Origination Form
Proposed Revisions to a Standard Plans Index

Originator:	Frimmel, James	**Index Number:**	522-002
Date:	4/29/2025	**Sheet Number(s):**	1 & 7 of 7
E-mail:	james.frimmel@dot.state.fl.us	**Index Title:**	Detectable Warnings and Sidewalk Curb Ramps

Summary of the changes:
Sheet 1: Added RAILROAD CROSSING Notes 1 and 2 from Sheet 7 as GENERAL NOTE 5, to to provide clarity on the 4'-0" full-height separation requirement. Sheet 7: Deleted the 4 - PLACEMENT OF SIDEWALK CRUB RAMPS AT CURBED RETURNS details.

CURB RAMP NOMENCLATURE

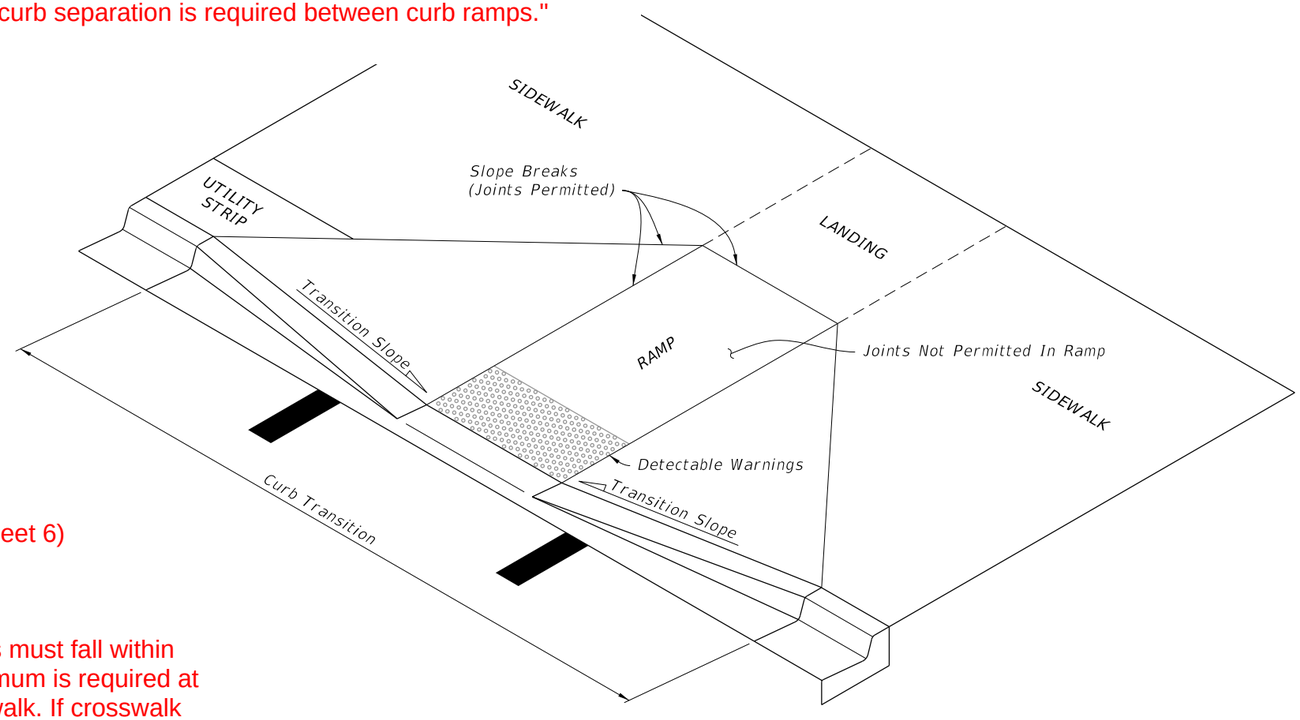
ADDED New Note 2.D:
"Where multiple ramps exist, a minimum 48" full-height curb separation is required between curb ramps."

ADDED New Note 5: (From Notes 1 & 2 on Sheet 6)

5. Crosswalks

A. Where crosswalk markings are used, ramps must fall within the crosswalk limits. A clear space of 48" minimum is required at the bottom of the ramp within a marked crosswalk. If crosswalk markings are not present, a clear space of 48" minimum is required at the bottom of the ramp outside of active travel lanes.

B. Crosswalk widths and configurations vary; must conform to Index 711-001.

RAILROAD CROSSING

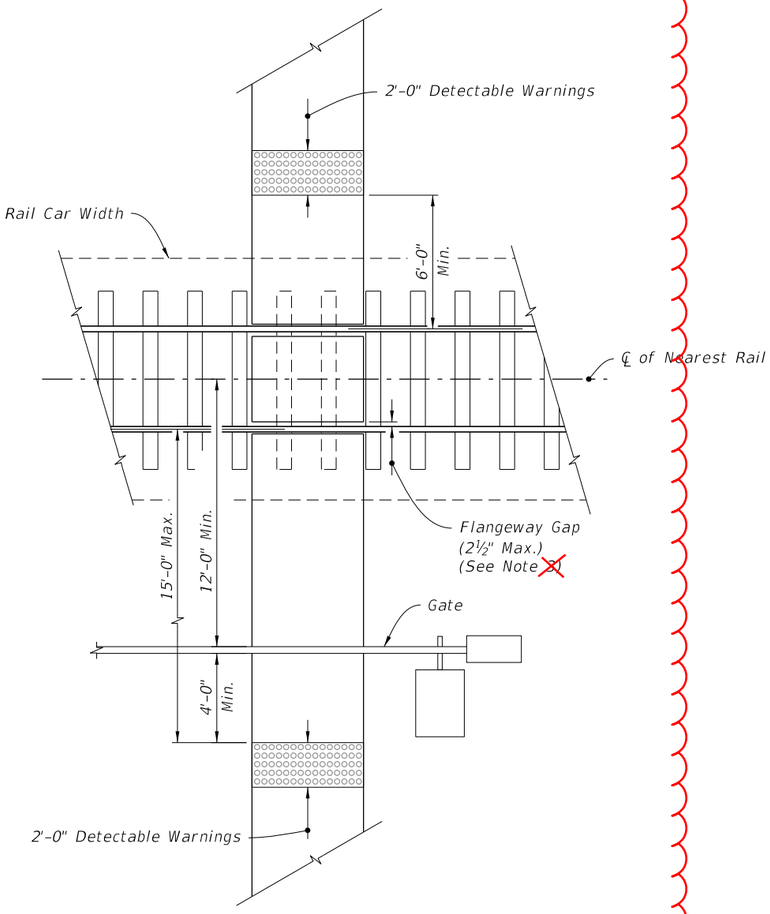
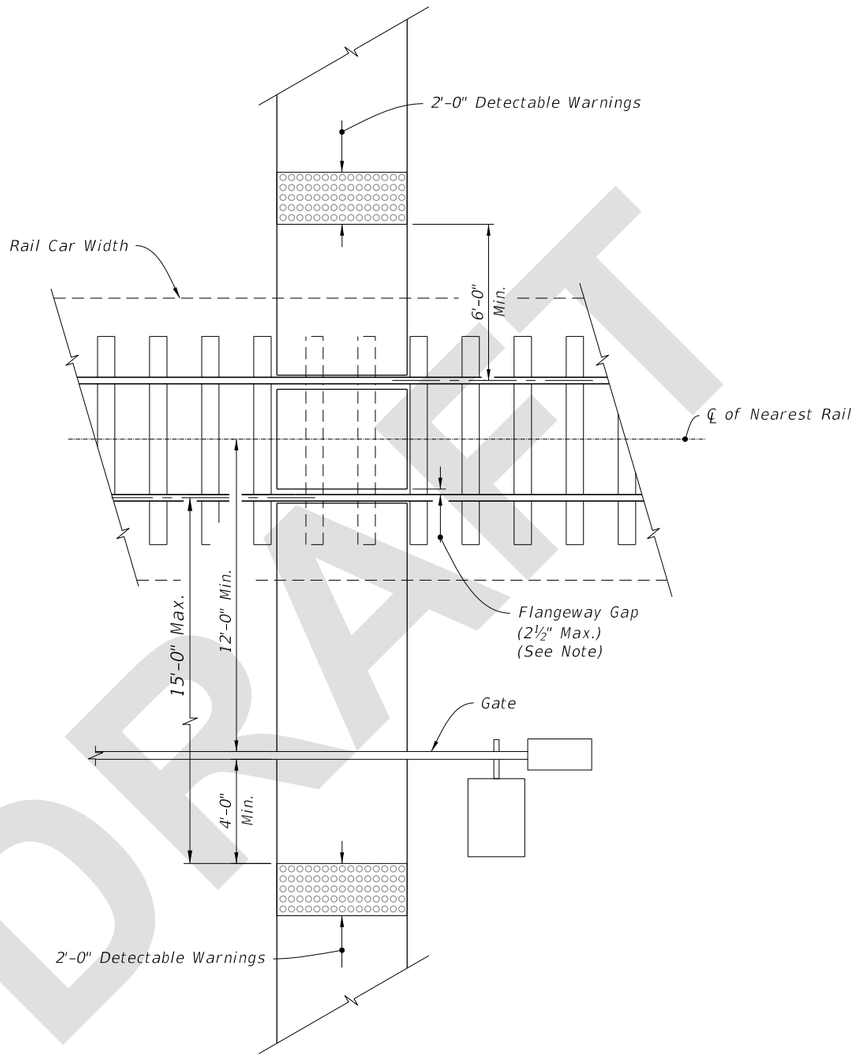
NOTES: MOVED: Notes 1 and 2 to Sheet 1

1. ~~Where crosswalk markings are used, ramps must fall within the crosswalk limits. A clear space of 48" minimum is required at the bottom of the ramp within a marked crosswalk. If crosswalk markings are not present, a clear space of 48" minimum is required at the bottom of the ramp outside of active travel lanes.~~

2. ~~Crosswalk widths and configurations vary; must conform to Index 711-001.~~

PLACEMENT OF SIDEWALK CURB RAMPS AT CURBED RETURNS (TYP.)

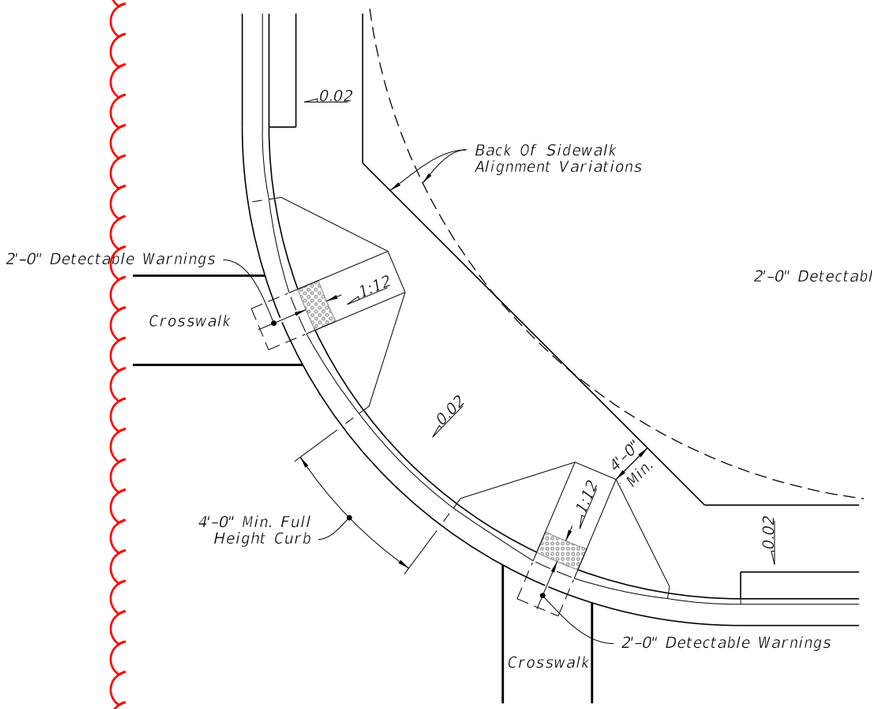
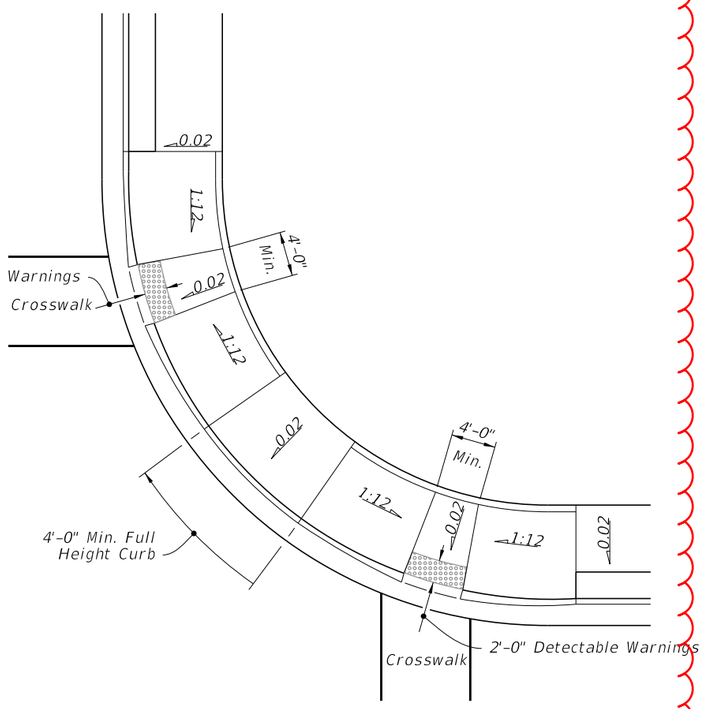
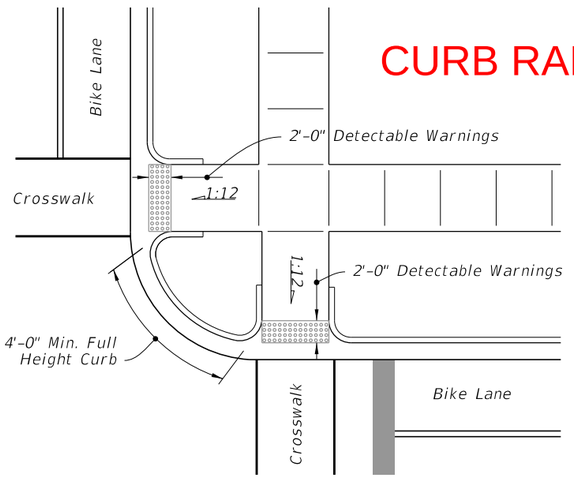
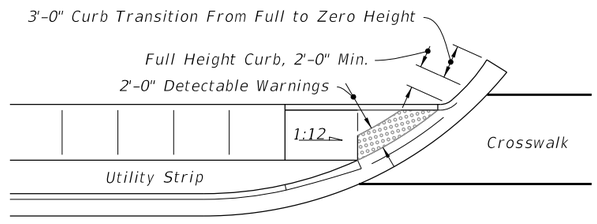
DELETED: CURB RAMPS AT CURBED RETURNS
